MANUFACTURERS OF WIPLINE FLOATS & SKIS SPECIALISTS IN AIRCRAFT MODIFICATION	Rev / Latest Rev. Date D/2-25-11	
	WIPAIRE, INC.	1700 Henry Avenue - Fleming Field South St. Paul, MN 55075 651-451-1205	Original Release 5/2/2007	
Prepared by	Aircraft Make / Model	Float / Ski Model	Page	
Jalon Sortor	Air Tractor Fire Boss Conversion	10000	1 5	
FAA Reviewed	Title		-	
	Fire Boss Foam Tank Securing			
ALL INFORMATION IN THIS SERVICE DOCUMENT BASED ON FAA APPROVED DATA

SERVICE KIT: 72

BAGGAGE COMPARTMENT FLOOR

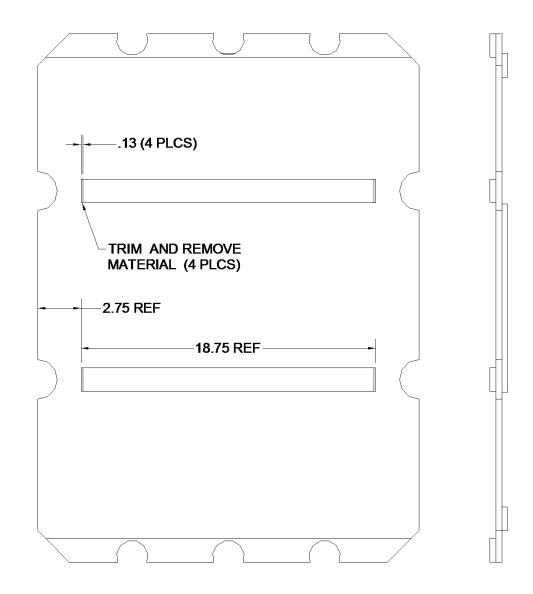
EFFECTIVITY	Fire Boss 10000 F	loat s/n 10115/10116 a	and below	
COMPLIANCE	At owner/operators	discretion		
BACKGROUND	We have collected several reports of broken cannon plug P/N 206429-1. This is a result of the plastic foam tank shifting around and breaking it off. The foam tank has also caused some surrounding bulkhead damage from the fluid inside bulging out the sides of the tank and rubbing the bulkheads.			
COMPLIANCE METHOD	Remove foam tank from aircraft. A new foam tank and hardware is included in this kit. See also included pictures and instructions below. Parts List is a per foam tank list:			
	Drill out rivel Install lip sea with MS2042	Foam Tank lip Seal outboard lip Seal inboard Lip Seal Bushing Bolt Washer m tank from float. ts and remove the lip seal 1004564 forward and 26-4 rivets. Top of lip sely .25' above top deck	nd aft, match o seals should l	drill and install

outboard edges (Ref. pg 5). This will insure the floor is resting on the bulkheads. Reinstall compartment floor. 7. Reinstall updated tank and check the distance from top of the lip seal to the top of the tank. It should be approximately 1.20". Match drill the holes from the new lip seals to the tank. Install bushings, washers and bolts. 		
SHOP HOURS	3 Hours per set of floats		
	10% parts discount for 18 months subsequent to Service Kit # 72 Rev. B release date of 3/30/10.		
WARRANTY
